Official Transcript of Proceedings
NUCLEAR REGULATORY COMMISSION

Title: Meeting of the Advisory Committee
On Reactor Safeguards

Reliability and Probabilistic Risk
Assessment (PRA) Subcommittee

Date: November 19, 2014

Part 1: Suggests that No CPRR Rulemaking Alternative can be a Substantial Safety Enhancement

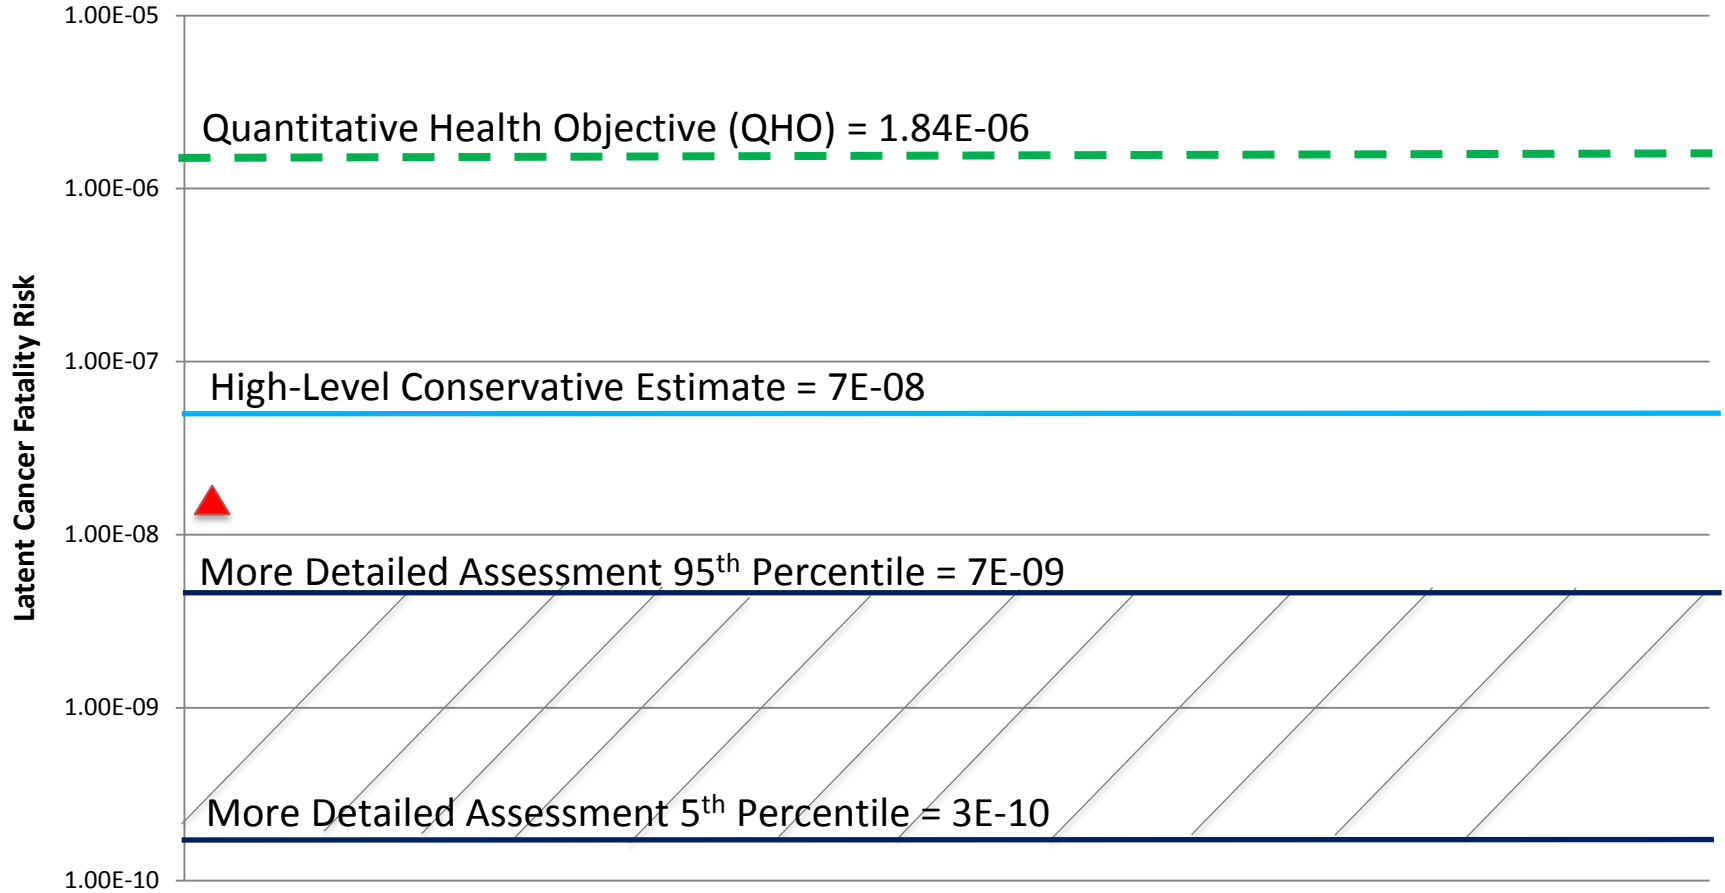
14 MEMBER BLEY; But the blue line is the one
15 we're talking about.

11 CHAIRMAN STETKAR: And, Aaron, I hate to
12 keep bringing you back to this, but that blue line there
13 --

15 CHAIRMAN STETKAR: -- you said that that is
16 accounting only for FLEX, what do you want to call it,
17 prevention or mitigation of FLEX before core melt. Is
18 that value based on Marty's event models?

21 Just one other -- I agree with John, but
22 just for the graphic, I think I know what you're trying
23 to show, but that black box that says "risk reduction"
24 and the double-ended yellow arrow doesn't -- I don't
25 know what the heck that means.

3 MEMBER BLEY: I'd almost get rid of -- I
4 would get rid of it unless you can make it more clear
5 what you're trying to show.

20 MEMBER BLEY: So either clean it up or get
21 rid of it, or live with it and get questions.

8 MEMBER SCHULTZ: I would think it would be
9 broader than that, because in the high-level evaluation
10 you've done; I agree with Dennis, this is not the right
11 way to determine the breadth of the yellow arrow band
12 there, but there's something that certainly is learned
13 in the evaluation that's done that frames the benefit
14 to be gained against one evaluation criterion that
15 provides good information about what benefit might be
16 achieved here. And one would think if you change the
17 metric evaluation you were doing it may not -- it
18 wouldn't appear that it would change the relative
19 benefit that would be gained for this class of reactors,
20 at least.

16 MR. SZABO: Yes. Yes. And so just to go
17 down just a little on the chart, you'll see that triangle
18 there was the expedited spent fuel pool which was in
19 COMSECY-13-0030, which was issued in November 2013, so
20 that was after the SRM that we received on this
21 rulemaking that had a latent cancer fatality risk of
22 1E-08. Within that COMSECY the staff recommended not
23 proceeding with expedited spent fuel pool transfer based
24 on the fact that this level of risk was so low that it
25 is not substantial and the Commission subsequent SRM

19 MR. SZABO: No, that is --

21 MR. SZABO: -- just taking the ELAP
22 frequency --

24 MR. SZABO: -- the highest ELAP frequency
25 and multiplying it times the highest bin MACCS

1 individual latent cancer fatality risk. That's all we
2 did.

7 MR. SZABO: One over times another times
8 0.6 for FLEX is all we did, yes.

Approximate Uncertainty Bounds for Individual Latent Cancer Fatality Risk

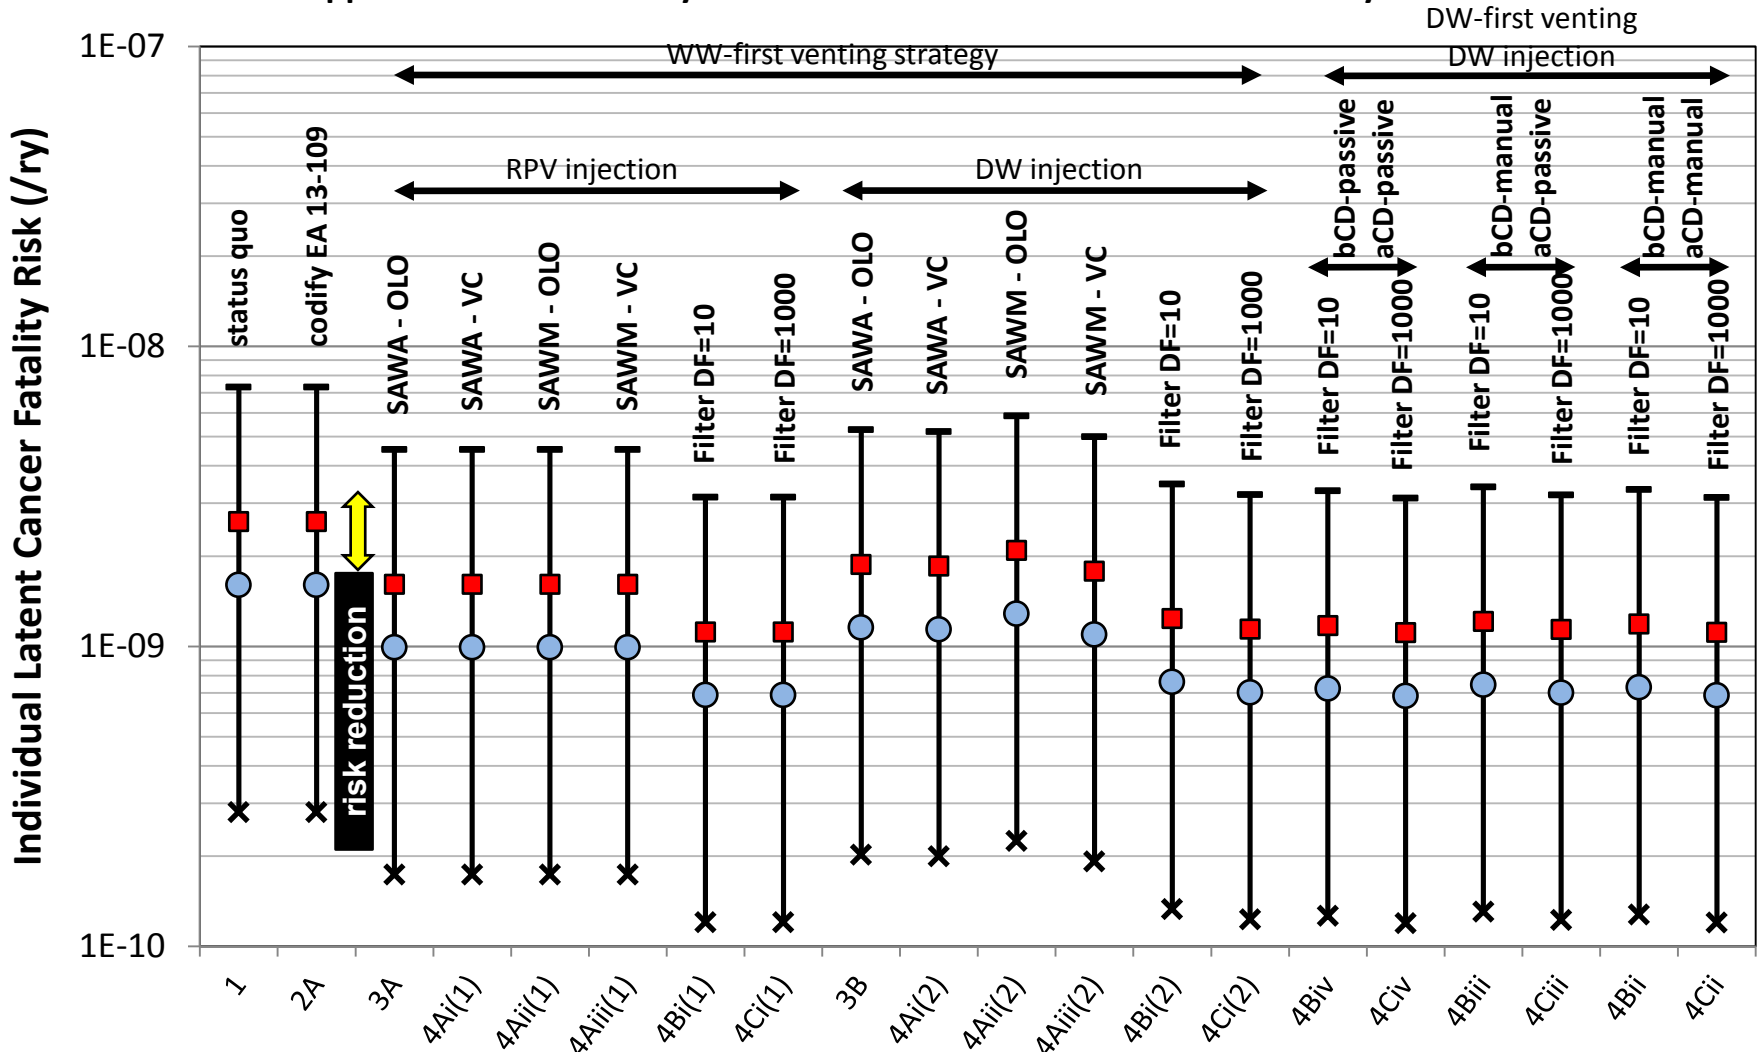
7 CHAIRMAN STETKAR: on the other hand,
8 saying that the operators could not work at all with
9 no uncertainty under some of those seismic scenarios
10 could change some of those error bounds by a factor of
11 anywhere from 3 to 10. So that's my point is it's not
12 -- there's a broader sense of uncertainty here than just
13 what has been quantified by these error bounds, and that
14 is are the humans actually treated correctly within
15 those models? And that's one of the reasons why we had
16 requested this briefing, to kind of dig into that. And
17 we're skirting that issue.

18 But on the other hand the previous
19 comparison that you showed said that it doesn't make
20 any difference. So all of this detail doesn't make any
21 different. My only personal caution is that if you show
22 all of this detail, don't try to assign too much
23 confidence in the fact that any of these things represent
24 reality regardless of what uncertainty or within the
25 context the source of that uncertainty.

1 orders of magnitude between the alternatives and that
2 it's merely just a small portion of something that's
3 been -- the uncertainty analysis, while it includes
4 human error probabilities in MACCS is dominated by the
5 seismic uncertainty, which improving the human error
6 probabilities would not change.
